April 16, 2008

RE: Geotechnical Considerations
St. Andrews Condominiums
Portland, OR

SECTION AT ROCK EXCAVATION
NTS

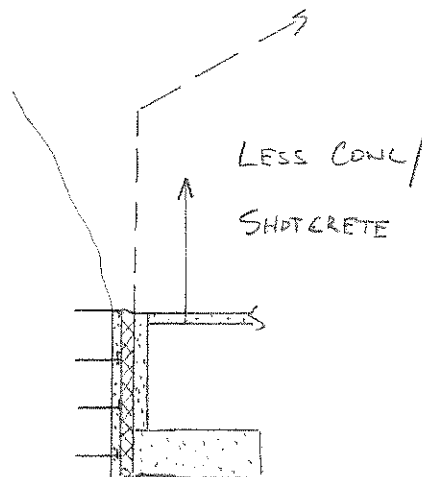
Review of the current site grading plan indicates that a significant portion of the east face of the new building structure will be directly adjacent to the vertical excavation. We recommend that at these locations, a rock anchor or soil nailed wall is constructed against the excavated surface to eliminate lateral earth pressures to the greatest extent possible. A drainage layer would then be constructed on the shoring wall with the addition of compressible material (approx. 4") to accommodate building movement under wind and seismic loading. The final building wall would then be placed against this drainage layer with a one-sided forming system (see attached sketch).

NOTE:
FOR THIS CONDITION, RIGID POLYSTYRENE BOARD IS NOT RES'D IN GAP (ONLY WATERPROOFING, THUS SIGNIFICANTLY REDUCING WIDTH OF THIS SPACE)
